DEPARTMENT OF PUBLIC WORKS AND ENVIRONMENTAL SERVICES

STAFF REPORT

Proposed Amendments to the PFM Re: Design of Public Streets and Sidewalks

Authorization to Advertise	<u>March 29, 2011</u>
Planning Commission Hearing	<u>May 5, 2011 at 8:15 p.m.</u>
Board of Supervisors Hearing	<u>June 7, 2011, at 4:00 p.m.</u>
Prepared by:	Code Analysis Division <u>JAC (703) 324-1720</u> March 29, 2011

STANDARD TYPICAL SECTION FOR TWO-LANE STREETS WITHOUT CURB & GUTTER (DITCH SECTION STREET)

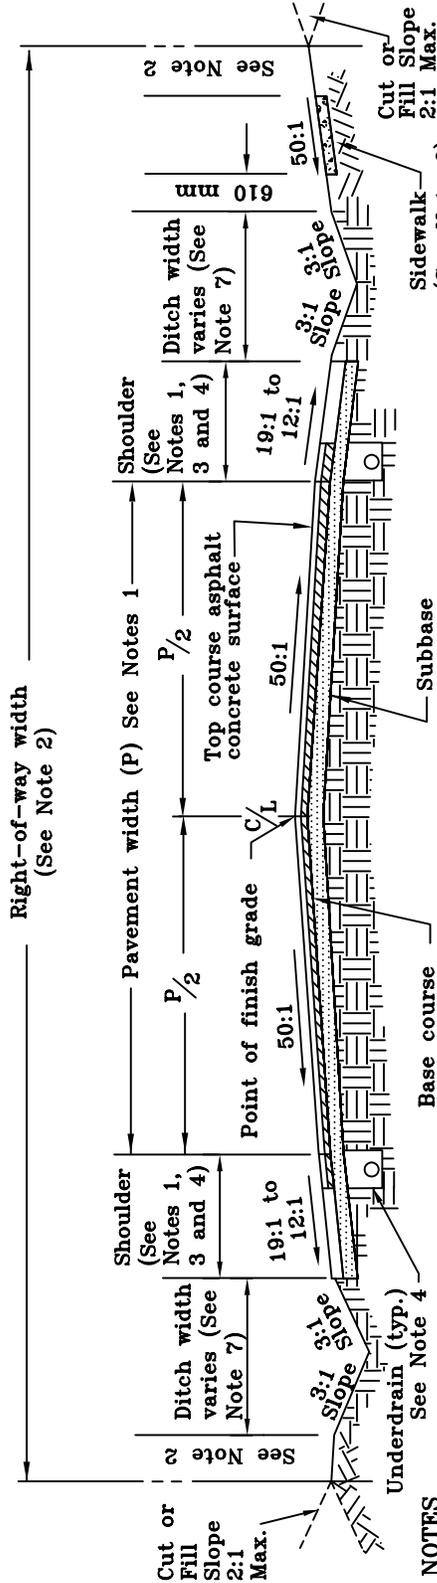
Amend Plates 1-7, 1M-7, 2-7, 2M-7, 3-7 and 3M-7 as follows:

- 1) Streets shall be designed in accordance with the VDOT Road Design Manual, except that the total roadway width, including the pavement and shoulders, for both one-way and two-way streets with parking on both sides shall be no less than 36 feet. The street widths shall accommodate parking on both sides of the street unless a no parking condition and/or a narrower roadway width is approved by the Board of Supervisors (Board) in conjunction with the approval of a rezoning, proffered condition amendment, special exception, or special exception amendment, and signed as approved by VDOT and the Director.

STANDARD TYPICAL SECTION FOR TWO-LANE STREETS WITHOUT CURB & GUTTER (DITCH SECTION STREET)

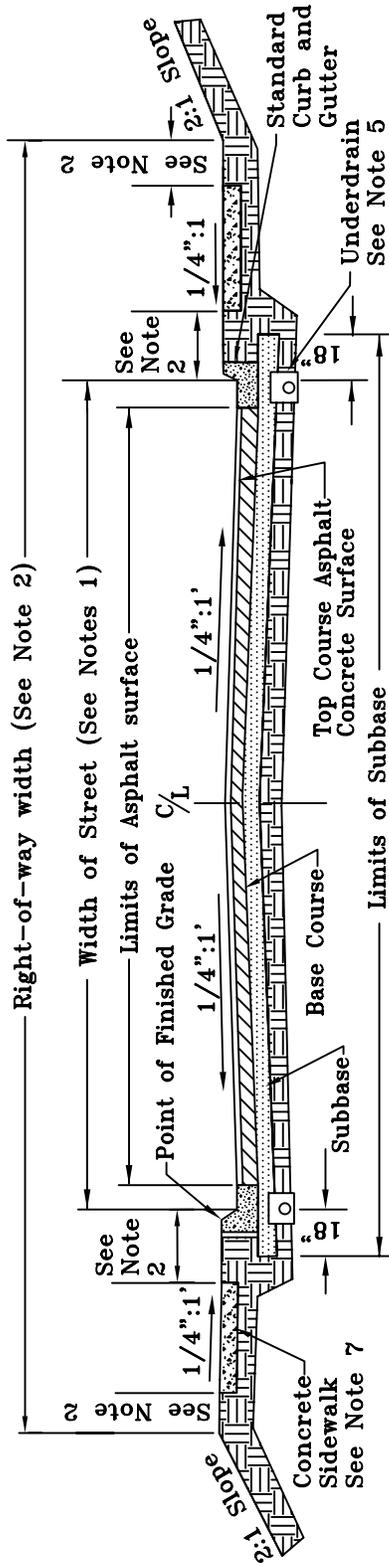
- 1) Streets shall be designed in accordance with the VDOT Road Design Manual, except that the total roadway width, including the pavement and shoulders, for both one-way and two-way streets with parking on both sides shall be no less than 11 meters. The street widths shall accommodate parking on both sides of the street unless a no parking condition and/or a narrower roadway width is approved by the Board of Supervisors (Board) in conjunction with the approval of a rezoning, proffered condition amendment, special exception, or special exception amendment, and signed as approved by VDOT and the Director.

STANDARD TYPICAL SECTION FOR UNDIVIDED STREETS WITH CURB & GUTTER

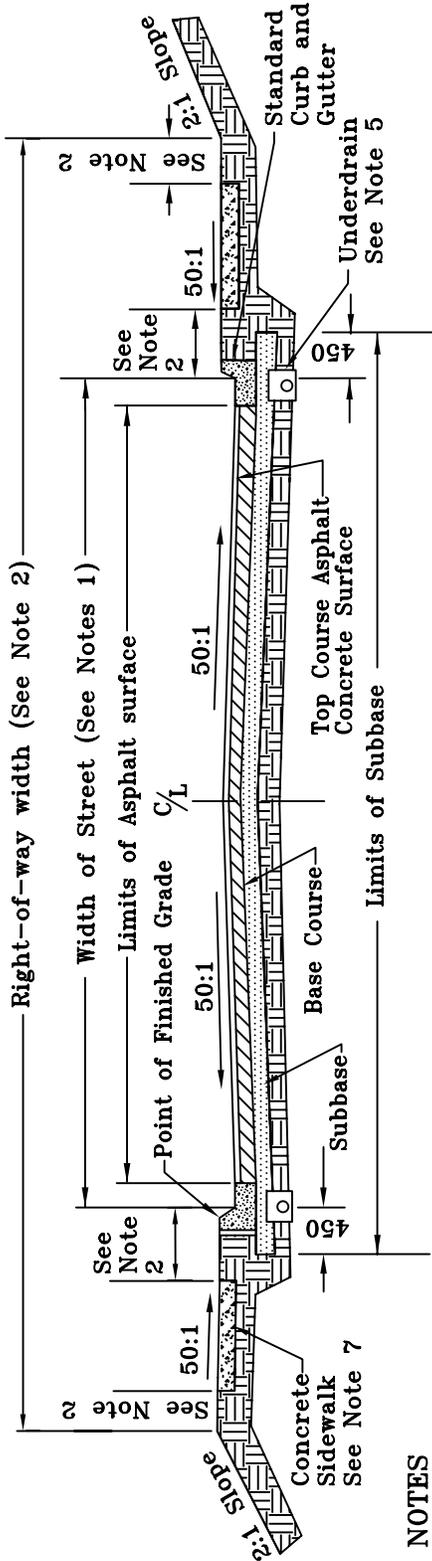
- 1) Streets shall be designed in accordance with VDOT Road Design Manual, except that the minimum street width shall be no less than 36 feet for both one-way and two-way streets with parking on both sides. Street widths shall accommodate parking on both sides of the street unless a no parking condition and/or a narrower street is approved by the Board of Supervisors (Board) in conjunction with the approval of a rezoning, proffered condition amendment, special exception, or special exception amendment, and signed as approved by VDOT and the Director.

STANDARD TYPICAL SECTION FOR MULTI-LANE STREETS WITH CURB & GUTTER

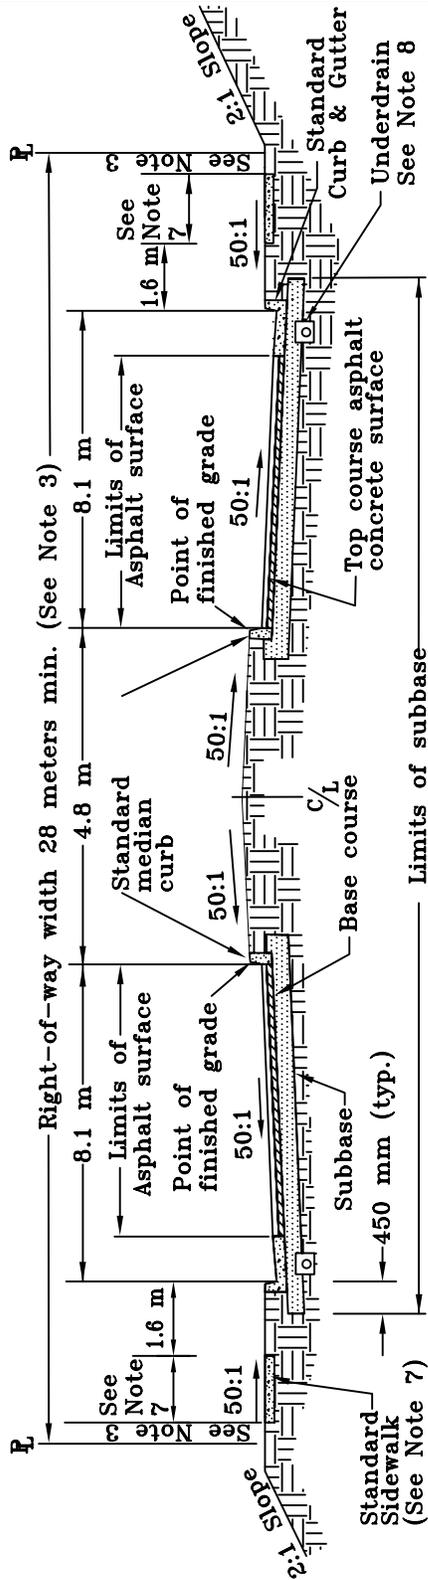
- 3) The right-of-way width shown is based on the features shown, which are to be maintained by VDOT. If additional features such as guard rail are required, the right-of-way width may change and shall accommodate all features, which are to be maintained by VDOT, in accordance with the current VDOT Road Design Manual. VDOT will accept sidewalk, which is a minimum of 1 foot from the right-of-way line.
